Design Review Board Meeting
May 19, 2016
Agenda Item: **5**

STAFF REPORT

To: Members of the Design Review Board
From: Planning Manager Watrous
Subject: 173 Stewart Drive; File No. DR2016036; Site Plan and Architecture Review for Construction of a New Single-Family Dwelling
Reviewed By: _____

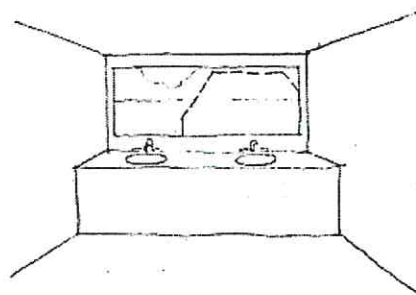
Goal 3, Principle 7 (A) of the Hillside Design Guidelines states that “view protection is more important for the primary living areas of a dwelling (e.g. living room, dining room, family room, great room, kitchen, and decks associated with these rooms) than for less actively used areas of a dwelling (e.g. bedroom, bathroom, study, office, den).” The upper level of the proposed house addition would intrude into the views from the kitchen, dining room and adjacent deck of the home at 175 Stewart Drive.

• PROPOSED STRUCTURE
BLOCKS BATHROOM VIEW

• LITTLE IMPACT ON
LIVABILITY

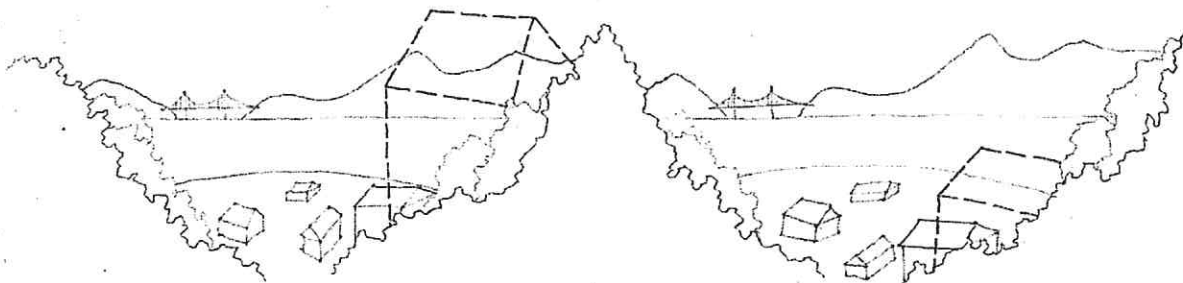
Goal 3, Principle 7 (B) of the Hillside Design Guidelines states that the “horizon line is [the] most sensitive part of [the] view, then foreground, then middleground.” The proposed upper level would be in the foreground view from the home at 175 Stewart Drive.

C. BLOCKAGE OF CENTER OF VIEW MORE DANGEROUS THAN BLOCKAGE OF SIDE OF VIEW.

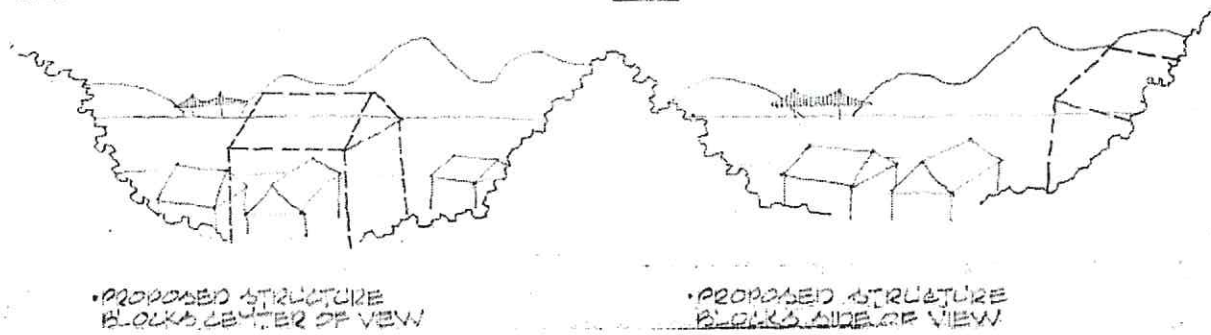
Goal 3, Principle 7 (C) of the Hillside Design Guidelines states that “blockage of center of [the] view [are] more damaging than blockage of [the] side of [the] view.” The proposed upper level would intrude into the center of the view from several vantage points in the home at 175 Stewart Drive.

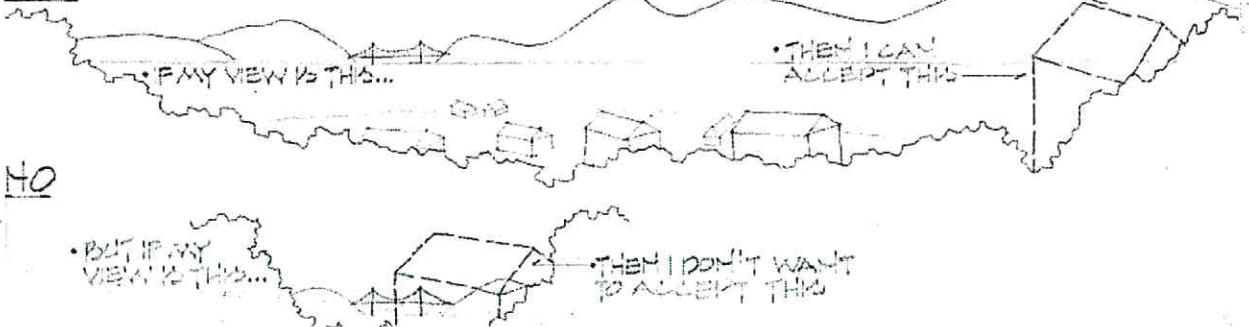
Goal 3, Principle 7 (E) of the Hillside Design Guidelines states that “a wide panoramic view can accept more view blockage than the smaller slot view.” The house at 175 Stewart Drive has a relatively wide panoramic view, including the Golden Gate Bridge, much of Richardson Bay and Sausalito. The proposed upper level would block only a small portion of the lower level water views from the primary living areas of the adjacent residence.
